AGENDA
GRAND MARAIS PLANNING COMMISSION
May 1, 2019, 4:00 P.M.

TO: Planning Commission
FROM: Mike Roth
DATE: April 25, 2019
SUBJECT: Winterstone Final Plat Application

Attached is the Final Plat entitled Winterstone submitted by Taiga Design+Build, LLC. This plat consists of 2.74 acres of property zoned R-1 split into 8 lots intended for single-family homes, and one outlot. The plat includes one new gravel public street, storm water ditches and pond, and new municipal utilities.

WINTERSTONE

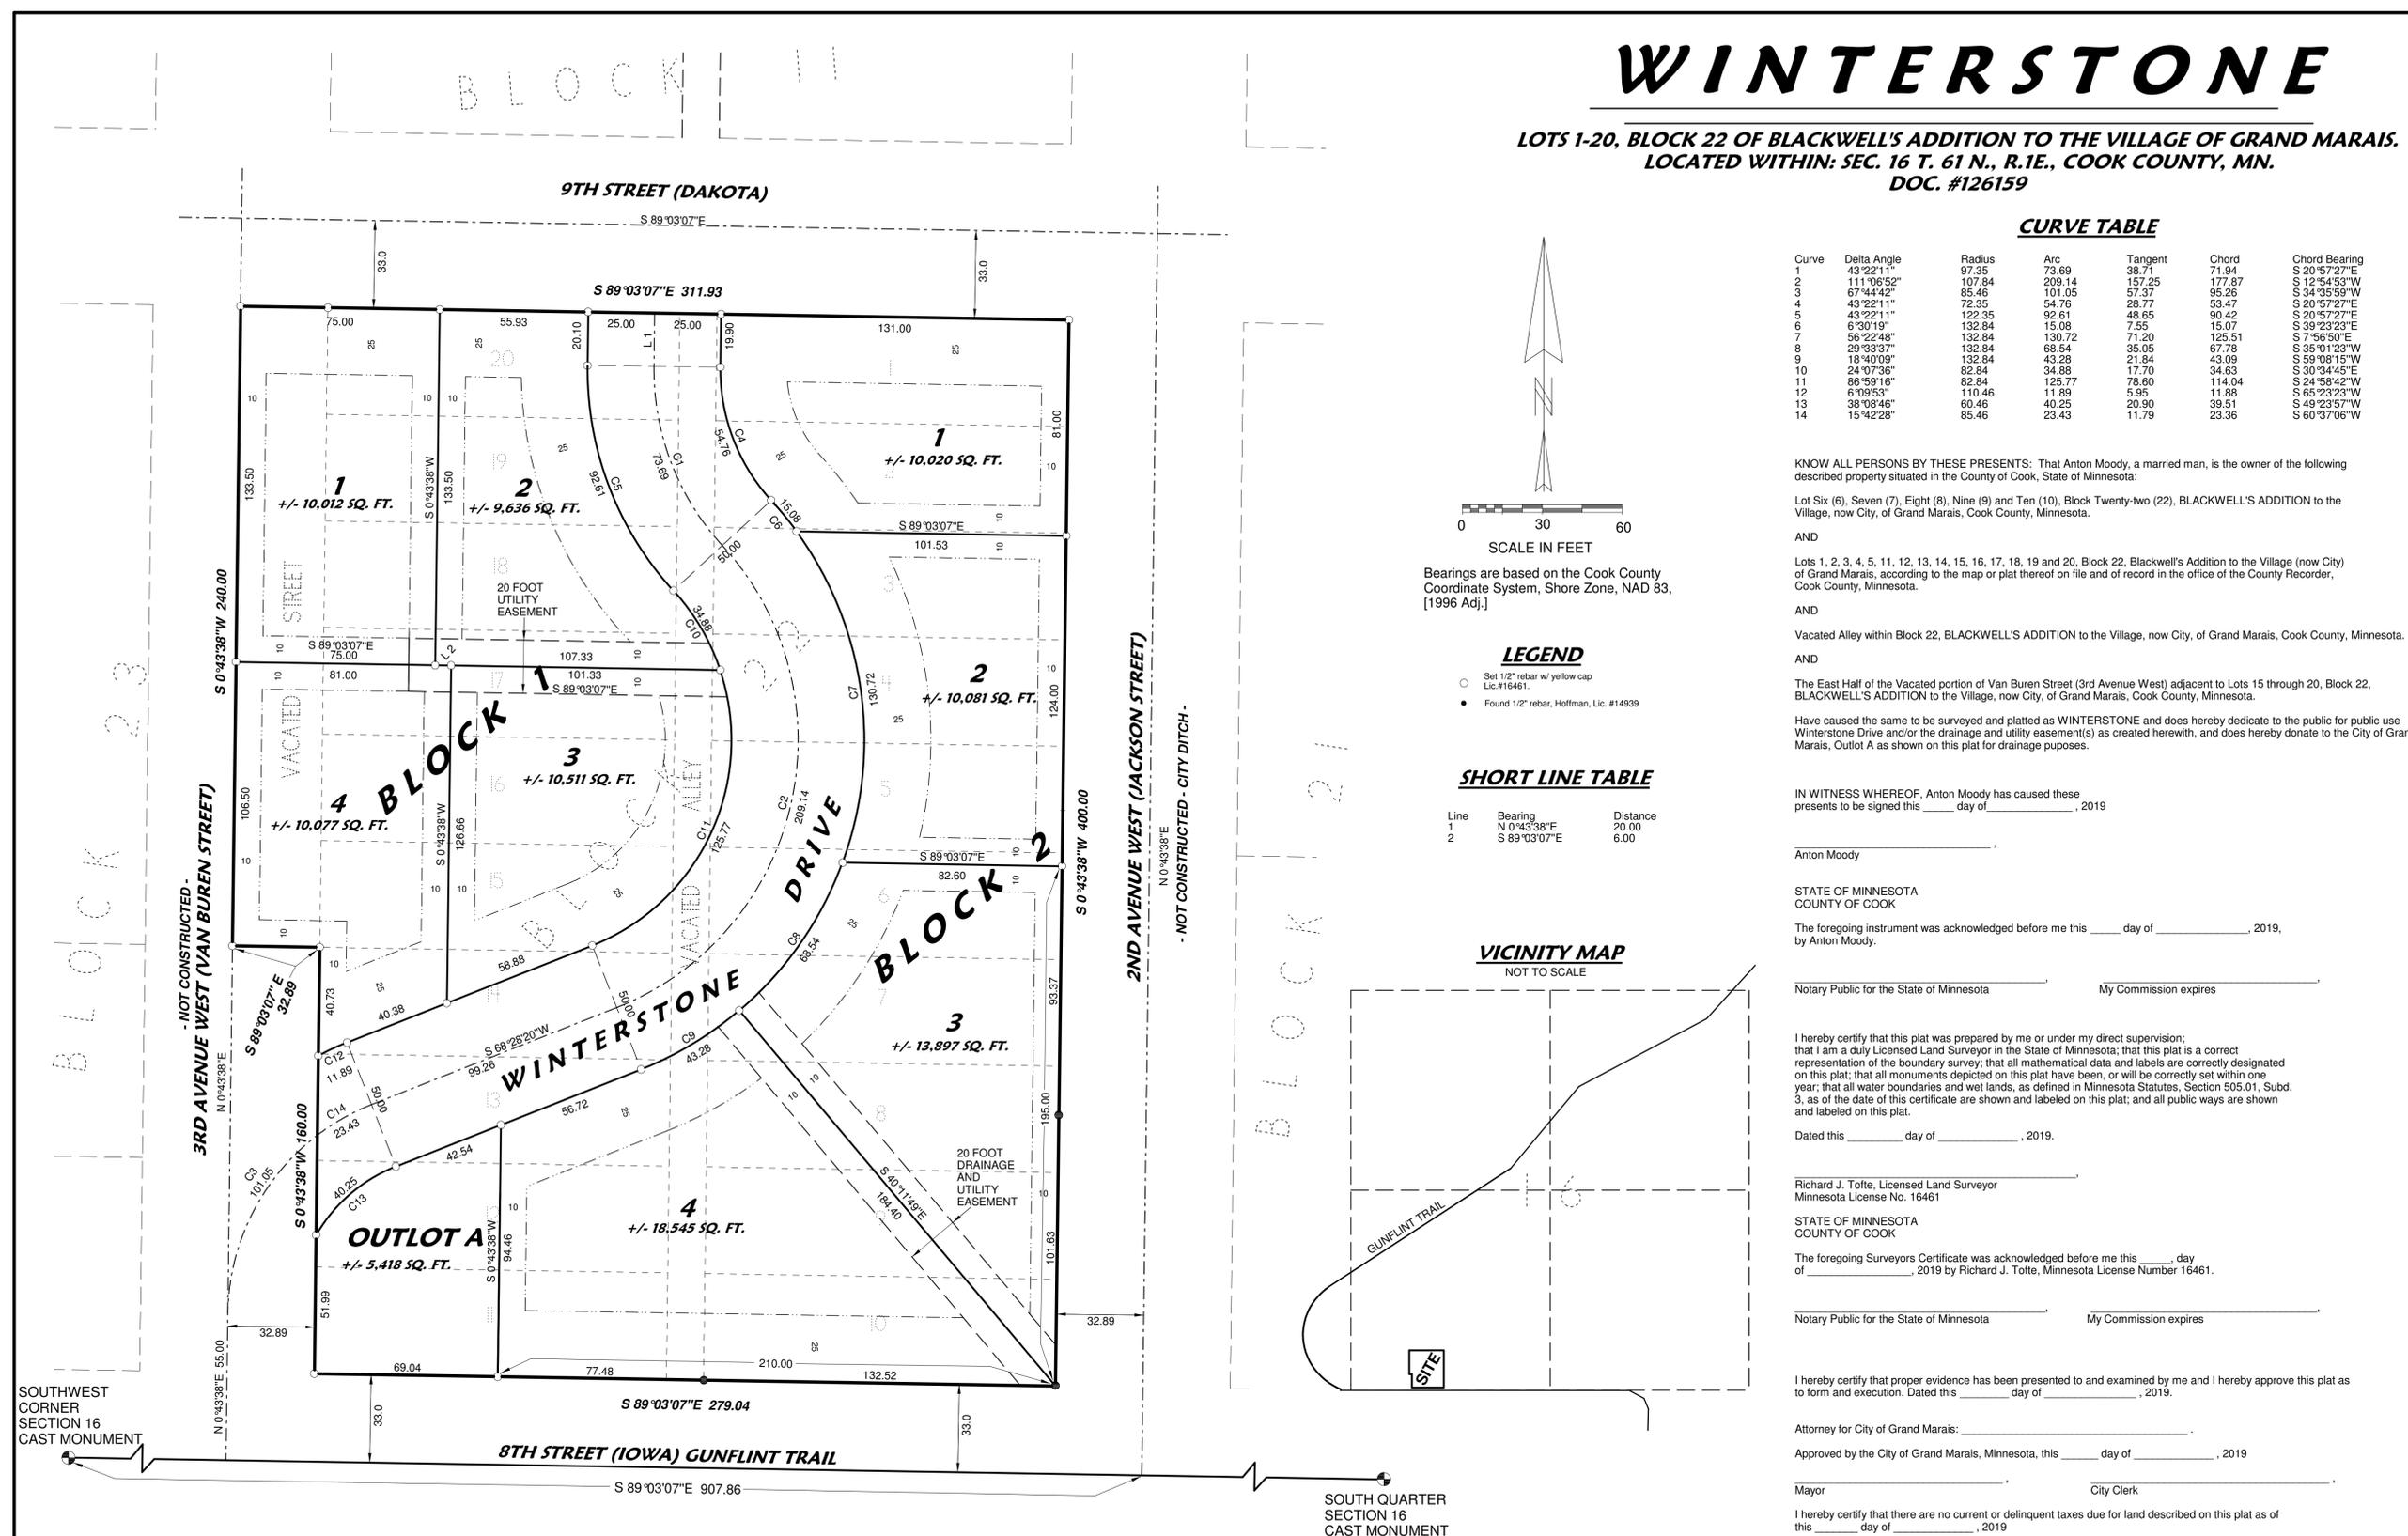
(a) *Block length.* In general, intersecting streets, determining block lengths, shall be provided at such intervals as to serve cross traffic adequately and to meet existing streets. Where no existing plats control, the blocks in residential subdivisions shall normally not exceed 1,000 feet in length, except where topography or other conditions justify a departure from this maximum. In blocks longer than 800 feet, pedestrian ways and/or easements within a block may be required. The width and location of such pedestrian ways shall be subject to the approval of the council. Blocks for business or industrial use should normally not exceed 600 feet in length. ***Both proposed blocks meet the requirement.***

(b) *Block width.* The width of the block shall normally be sufficient to allow two tiers of lots of appropriate depth. Blocks intended for business or industrial use shall be of such width as to be considered most suitable for their respective use, including adequate space for off-street parking and deliveries. ***Due to the use of the adjacent 2nd Avenue right of way for drainage, the blocks have one or two lots of depth.***

(e) Under normal conditions, streets shall be laid out so as to intersect as nearly as possible at right angles except where topography or other conditions justify variations. The minimum angle of intersection of streets shall be 80 degrees. Street intersection jogs with an offset of less than 125 feet shall be avoided. ***Intersections are at 90 degrees.***

Where existing or anticipated traffic on arterial streets warrants greater width of rights-of-way, these shall be required. ***The proposed right-of-way width is less than the required 66', approved in the preliminary plat contingent on acceptance of the engineered plans.***

In addition, there shall be a minimum grade on all streets of not less than four-tenths of one percent. ***The proposed grade is less than the maximum of 10%.***

(a) The minimum lot area, width and depth shall not be less than that established in the zoning ordinance. *Two lot dimension variances were granted with the preliminary plat: Lot 2, Block 1, is proposed at 9,636 sq', less than the required 10,000. Lot 2, Block 2 is 101' deep, less than the required 120'. All other lots are sufficient.*

(c) Where a subdivision is traversed by a watercourse, drainageway, channel or stream, a stormwater easement, drainage right-of-way or park dedication, whichever the council may deem the most adequate, conforming substantially with the lines of such watercourses, shall be provided, together with such further width or construction, or both, as will be adequate for the surface water drainage of the area. The width of such easements shall be determined by the council. *No drainageways are identified on the plat. A wetland delineation is included.*

In subdividing land or resubdividing an existing plat, due consideration shall be given by the subdivider to the dedication or reservation of suitable sites for schools, parks, playgrounds, conservation areas, or other public or semipublic recreational areas or open spaces. Areas so dedicated or reserved shall conform as nearly as possible to the comprehensive plan. All areas to be reserved for or dedicated to public use shall be indicated on the preliminary plat in order that it may be determined when and in what manner such areas will be dedicated to or acquired by the appropriate agency. *One open space outlot is included in the plat.*
